California Regional Water Quality Control Board
Santa Ana Region

SUBJECT: Waste Discharge Requirements for the U.S. Army Corps of Engineers & San Bernardino County Flood Control District, San Timoteo Creek Reach 3B Flood Control Project - Order No. 01-75

ERRATA SHEET

Attachment "C"

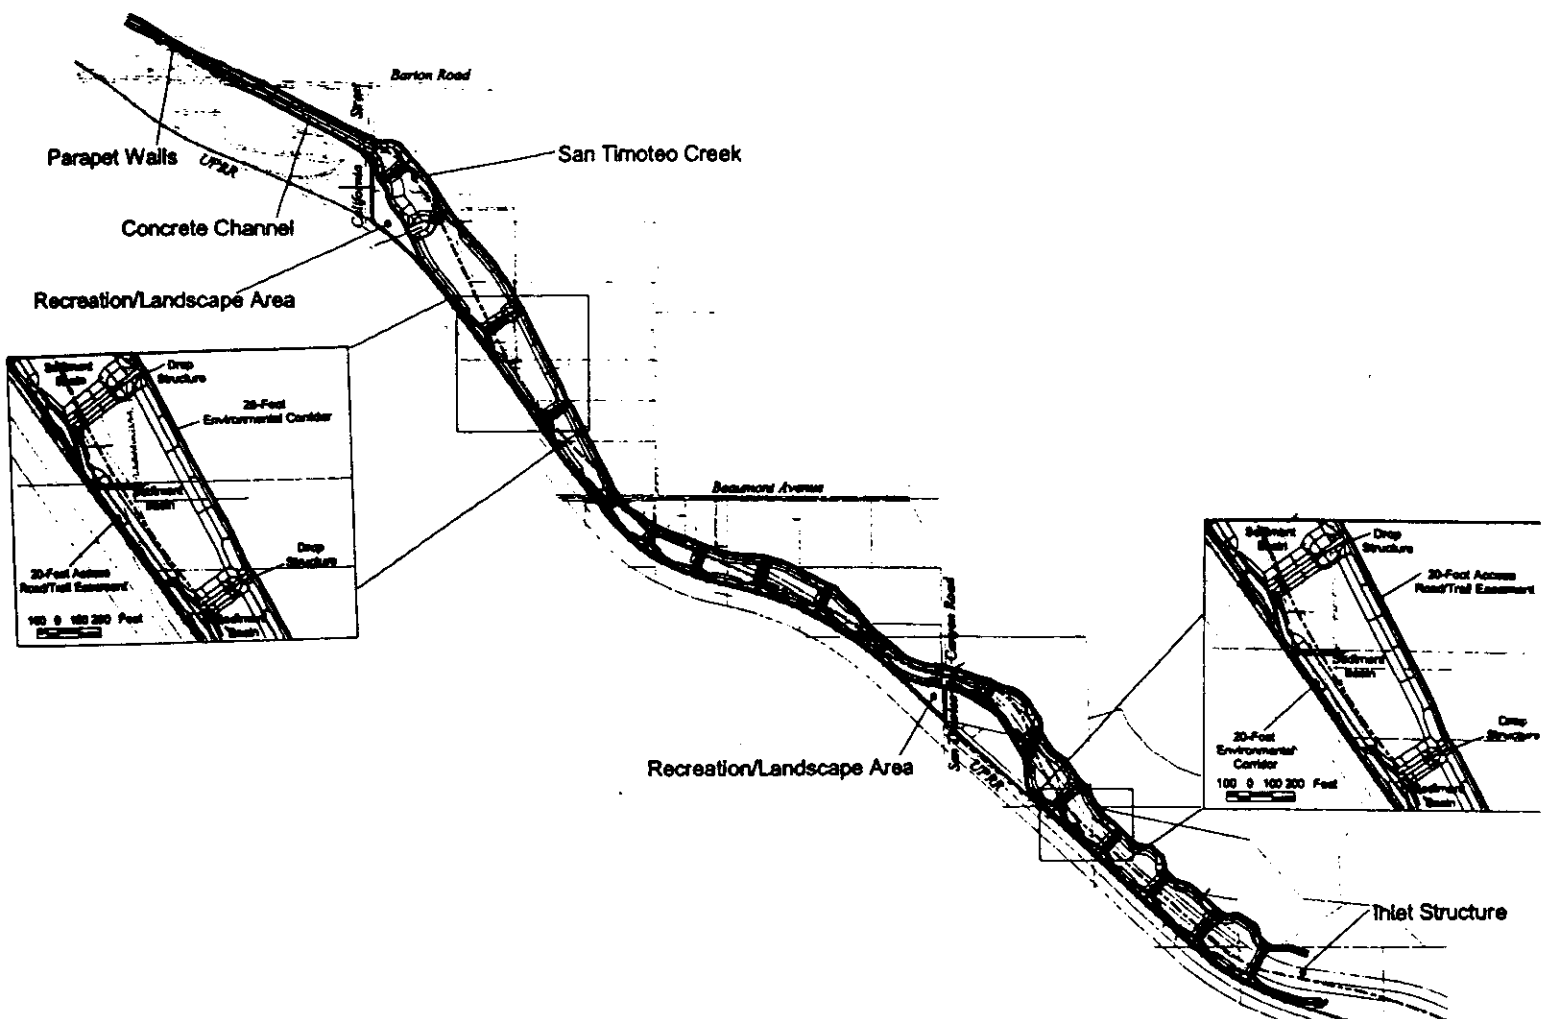
4. Staff Report, Attachment "C", revise the Title as follows:

~~PROJECT LIMITS~~ PLAN LAYOUT OF SEDIMENTATION BASINS
